## Attachment B – Tables of Compliance

## ENVIRONMENTAL ASSESSMENT

The application was referred to the Liverpool Design Excellence Panel (DEP) on 13 November 2025. At its meeting the panel voted that **the proposal is not supported** and must return to the panel, with all feedback incorporated or addressed.

**Figure 1:** Proposed signage along southern elevation.

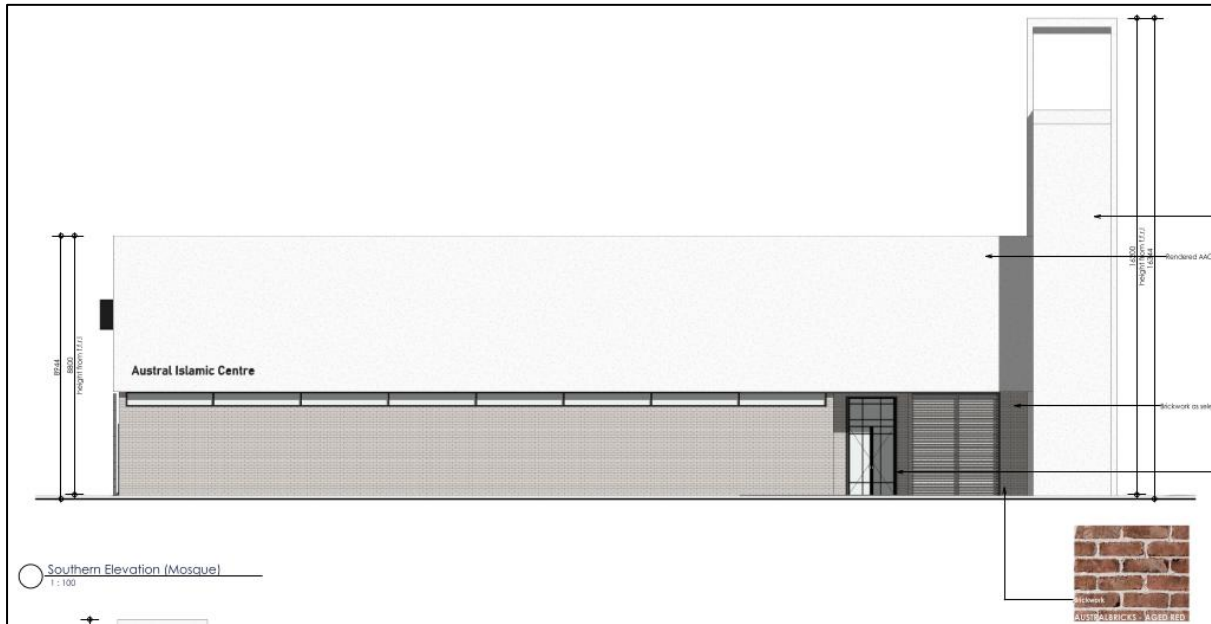
The only signage indicated on the Architectural Plans relates to the Mosque, in which business identification signage states “Austral Islamic Centre”.

Figure: Extract from Civil Engineering Plans

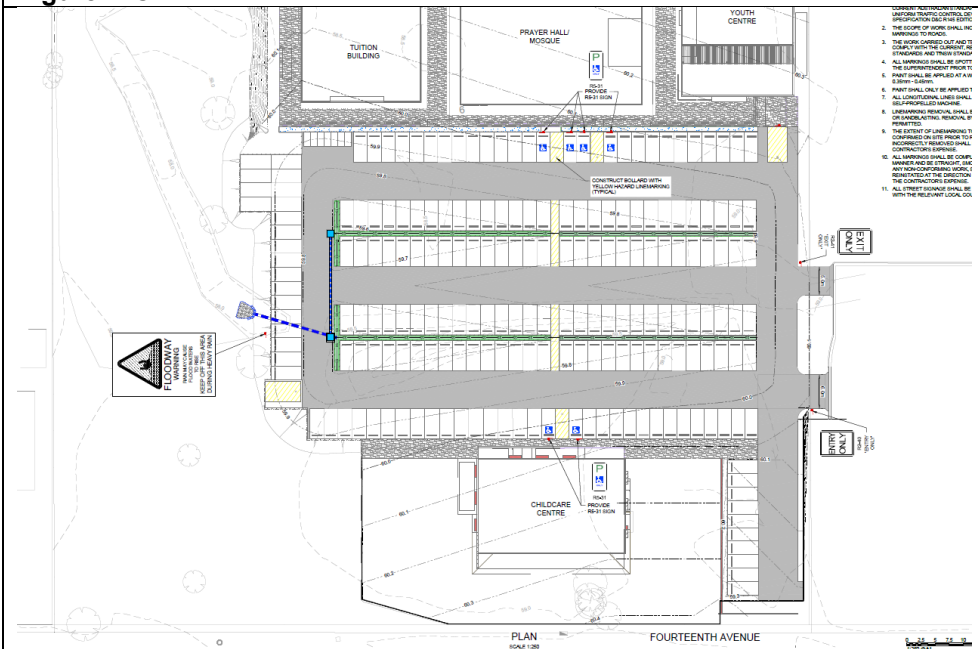
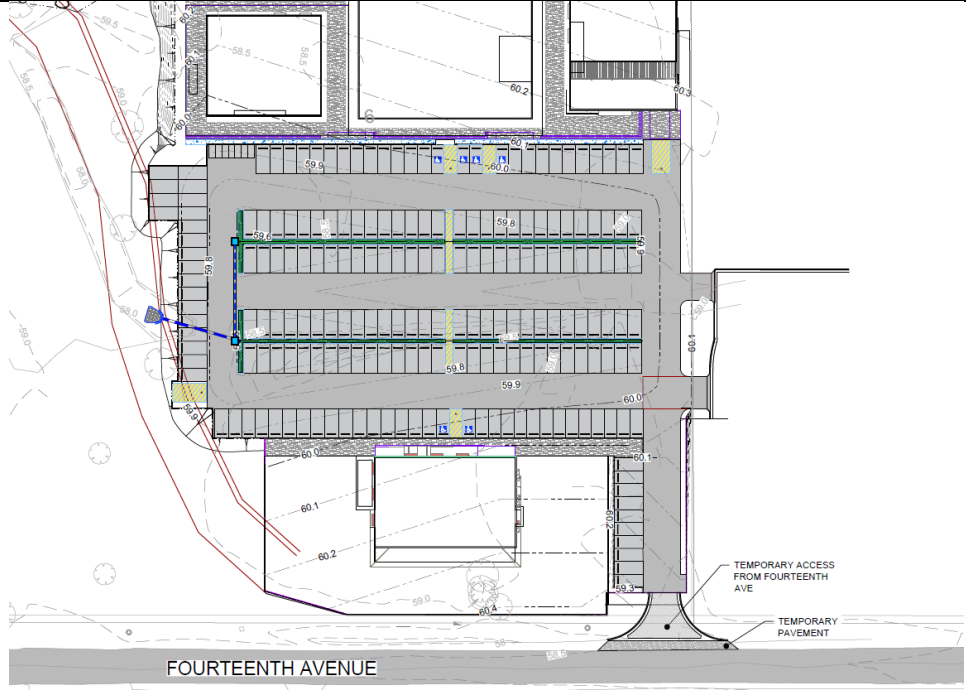
Development Control	Provision	Comment
3.3.7 Temporary vehicular access	Temporary access roads are to remain in operation only until such time as the road network has been developed to provide permanent access to all properties. A section 88B instrument is required as part of the subdivision requiring that the temporary access road remains open for as long as necessary to ensure access to all properties.	<b>Additional Information Required</b> The provided Civil Engineering Plans indicate that access from Fourteenth Avenue it to be temporary.  Given that access from the site to the east is not yet available a deferred commencement condition may be required. Alternatively, access from Fourteenth Avenue may be retained as the primary entry point with the connection to the neighbouring site the subject of a future development application.
	 <p><b>Figure:</b> Extract from Civil Engineering Plans</p>
